PRODUCT CHANGE NOTICE PCN Form (D4-E000-73)

PCN#19-092

Change to recommended PL customer layout drawing

PL Drawings

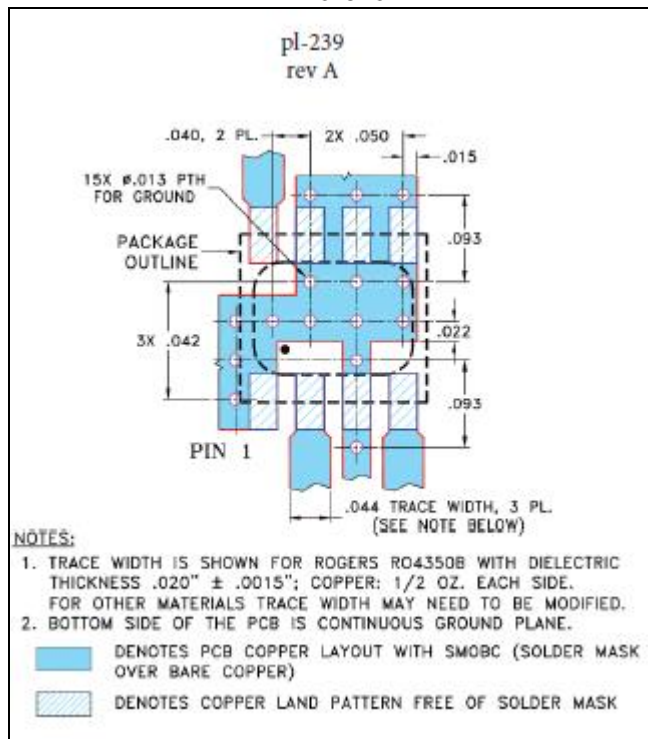
- No change to device **FIT** (dimensions), **FORM** (appearance), or **FUNCTION** (performance)
- Change to layout to reduce the amount of ground solder under the device
- Refer to PL drawing linked to the part datasheet

Customers reported insufficient ground solder appearance during Pick and Place. This resulted from excess exposed ground pads ‘sucking’ solder under the device. Revised PL drawing realigns the ground areas for optimal joint formation
